SUBJECT: FCC Class II Permissive change for FCC ID: U7I-BP3KV1-5W

We, the undersigned, would like to request a Class II Permissive Change for the FCC ID: U7I-BP3KV1-5W, which was originally granted on 02/14/2022.

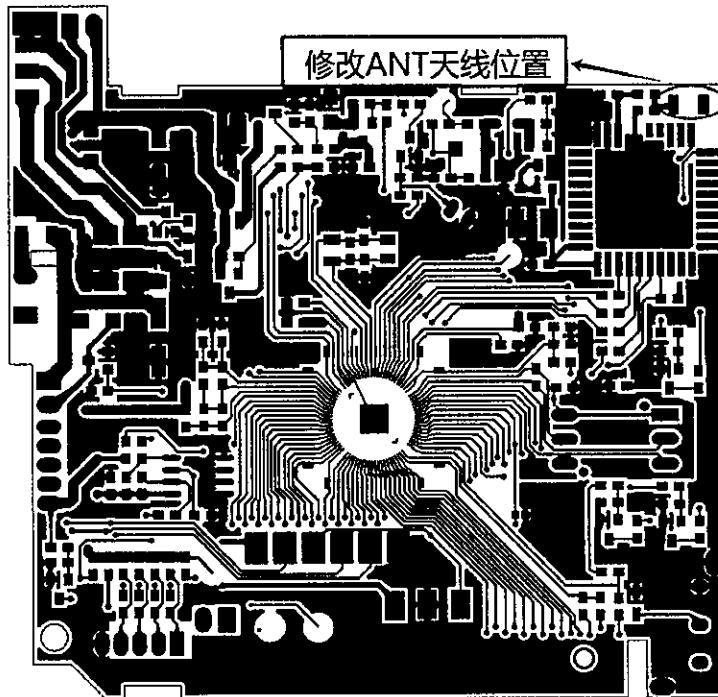
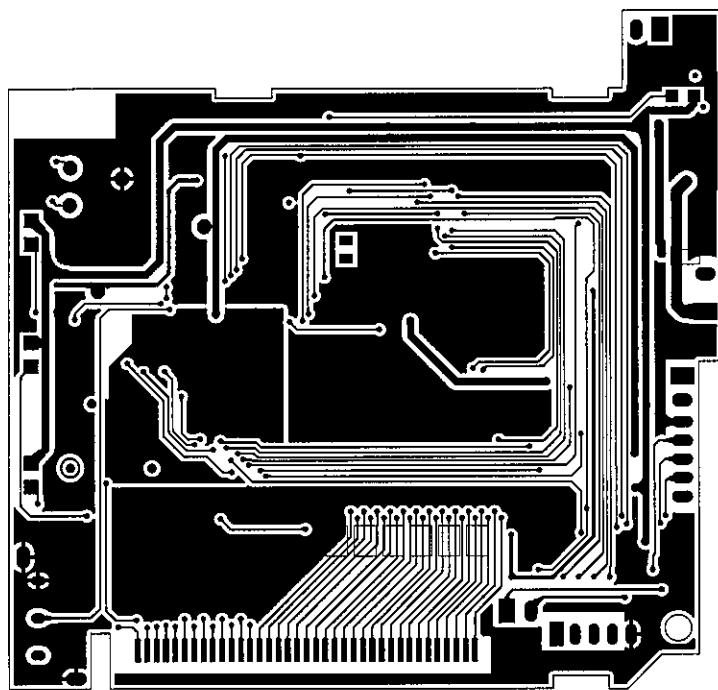
- ① Canceled the USB function: PCB was not changed.
- ② The position and model of the antenna in the upper right corner are changed:

Before change:

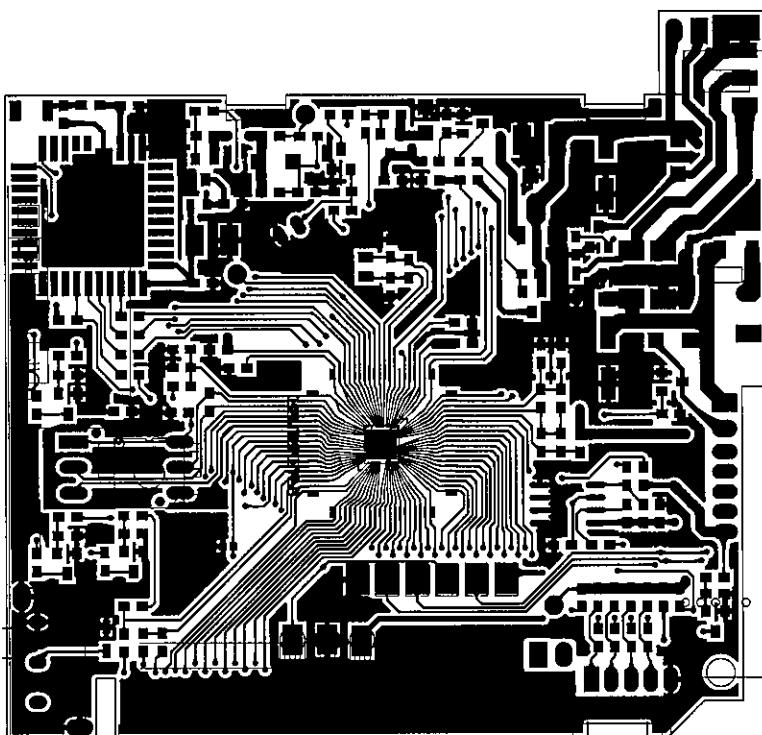
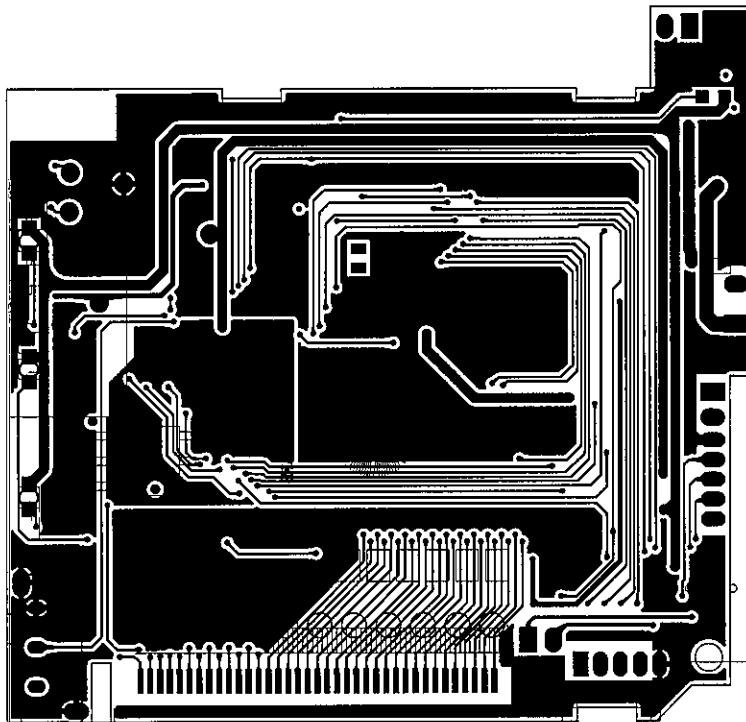
Antenna parameter:

Before: BTCAKC321609002G4Y SMD3.2x1.6x1.2mm (Xiamen Holder Electronics Co.,Ltd)

New: ANT3216R24003KL0 SMD 3.2x1.6x0.6mm (Shenzhen P.D.T Electronics Co.,Ltd)
